Access Compliance Report

Public Rights-of-Way

| Intersection ID: 13420 | Main Street: S_TRYON_ST | Cross Street: W_BLAND_ST | Location: NE |
| ADA ID: 96BEA3F12AAC | Ramp Type: Perp | Initial Pass/Fail: Fail | Overall Compliance: No |

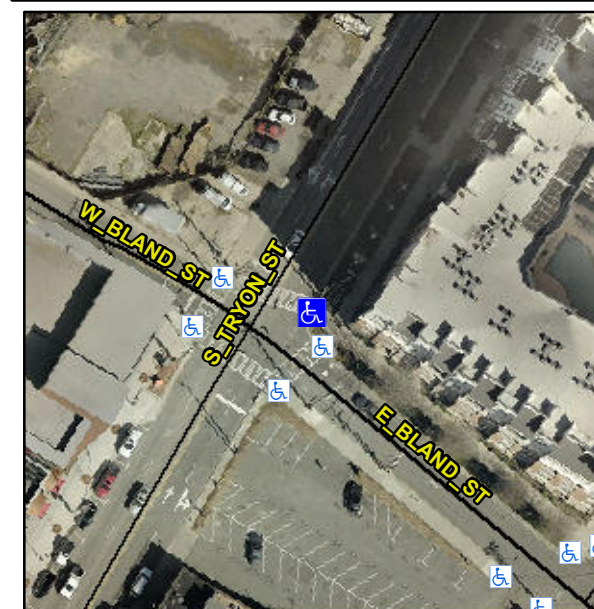
Not Found, R304.2.2

| Compliance | Description | Data | Compliance | Description | Data |
|------------|-----------------------|-------|------------|-----------------------------|------|
| N/A | Ramp Length (in) | 67.0 | No | Ramp Slope (%) | 8.8 |

Remove & Replace Entire Ramp.
